CONSTRUCTION SUMMARY

Forestside Estates Inc.

LOT NUMBER	PHASE	HOUSE TYPE	CLOSING DATE	
241 BLOCK 5	6-III	Blue Ash 2A2	01-May-23

Suite: 241

OPTION 2

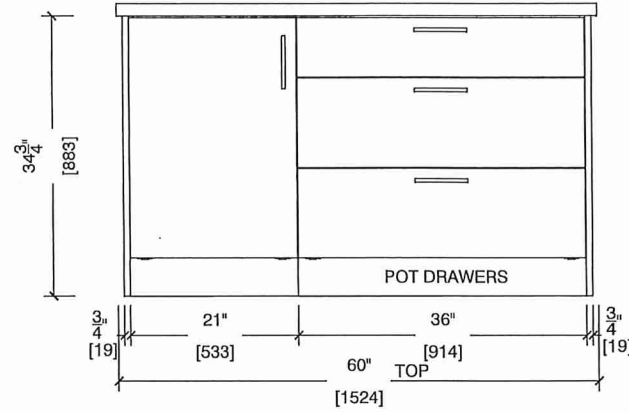
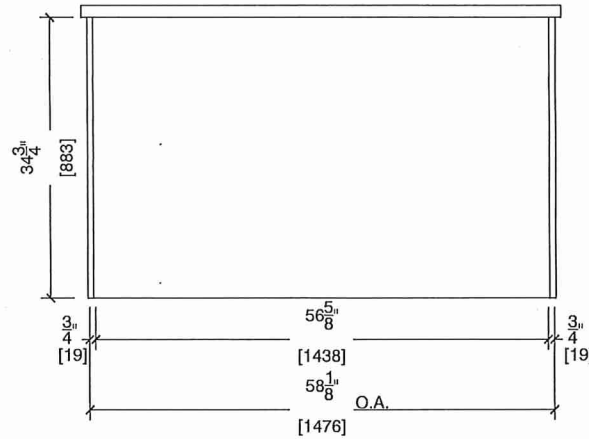
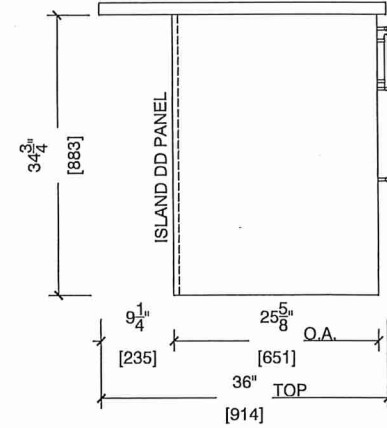
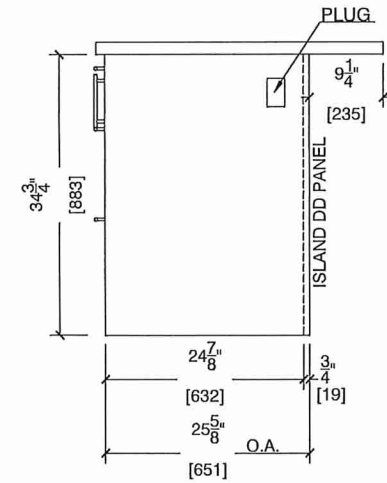
1 - KITCHEN - CABINETRY - Install OPTIONAL ISLAND inside the kitchen . To include pot and pan drawers. (See Sketch)
Note:

1 - KITCHEN - COUNTER - Install EMMERSTONE (Gray Galaxy) with the standard "A" edge throughout the optional island where applicable. (See Sketch)
Note:
